ADDENDUM 2  
DB/STP-0029-03(009)/102556-304000

Marshall County

**PROJECT:** Design and Construction of I-269 in Marshall County  
Project No. DB/STP-0029-03(009) / 102556-304000

SUBJECT: **Special Requirements at the Coldwater River Crossing**

**Figure 6004.1**

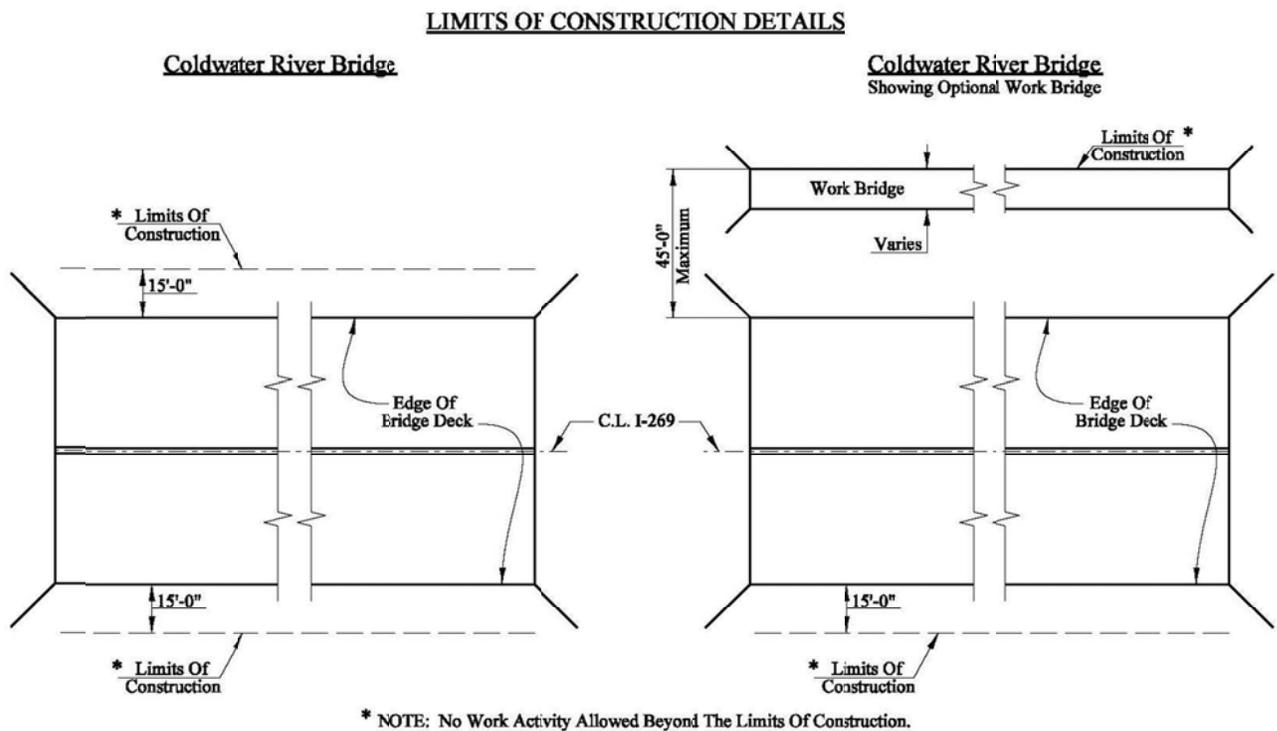
One (1) bridge structure is required for the Coldwater River Crossing. The Contractor may utilize a temporary work bridge on only one (1) adjacent edge of the mainline bridge. Multiple temporary work bridges are not allowed. The outside edge of the temporary work bridge may be located a maximum 45' from the edge of the mainline bridge. The temporary work bridge shall be constructed by means that satisfy the ground rutting and turbidity restrictions stated herein.

The Contractor shall limit all work activities to the construction limits. The construction limits shall be located 15 feet from the outside edge of the mainline bridge deck. No additional construction limit will be allowed beyond the temporary work bridge. The construction limits and work bridge limits are detailed in Figure 6004.1. Prior to any work in the area, the Contractor shall delineate the construction limits of the Project with suitable materials to clearly mark the construction limits of the Coldwater River Crossing. At the end of the Project the Contractor shall remove all delineation of the construction limits for the Project.
